INSTALLATION MANUAL

REF NO.
 BT00047

SUBJECT: INTRODUCTION OF SALT DAMAGE/CORROSION RESISTANT STAINLESS PARTS FOR WA500-3

- **PURPOSE:** To introduce newly prepared stainless steel made parts (handrails and muffler stack) which are effective to prevent occurrence of salt damages and corrosions for use on WA500-3 wheel loaders
- APPLICATION: WA500-3 Wheel Loaders, Serial Nos. 50001 and up

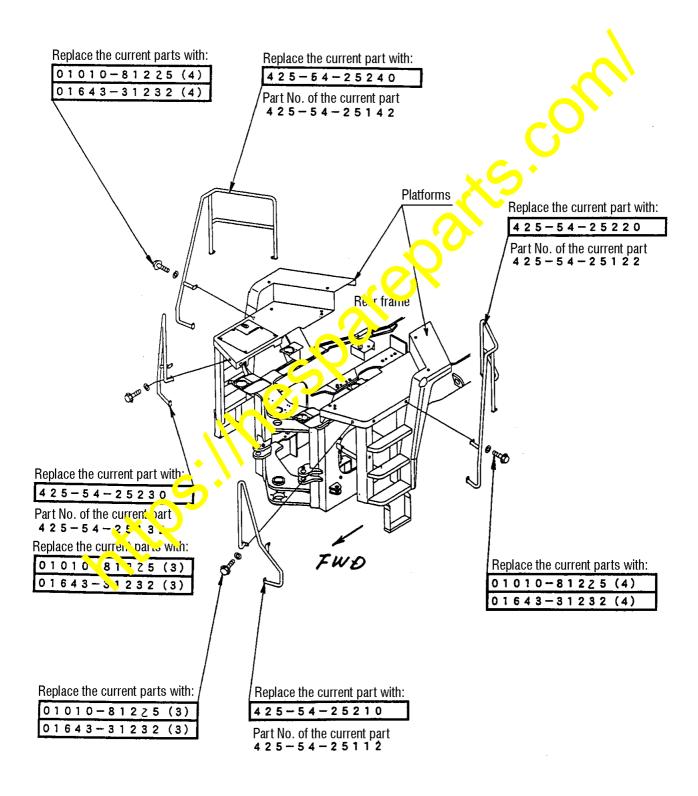
① Replace the current hand rails with the stainless steel hand rails.

(Precautions) · As for the mounting bolts, replace the flanged bolts with the newly prepared bolts.

- Parts in thick-lined blocks _____ are the newly prepared parts for this modification.
- \cdot Bolt tightening torque: 98 123 Nm (10.0 12.5 kgm)

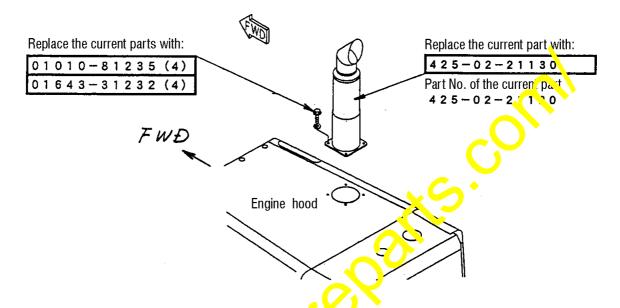
② Replace the current muffler stack with the stainless steel muffler stack.

(Precautions) · As for the mounting bolts, replace the flanged bolts with the newly prepared bolts.

- Parts in thick-lined blocks _____ are the newly prepared parts for this modification.
- · Bolt tightening torque: 98 123 Nm (10.0 12.5 kgm)
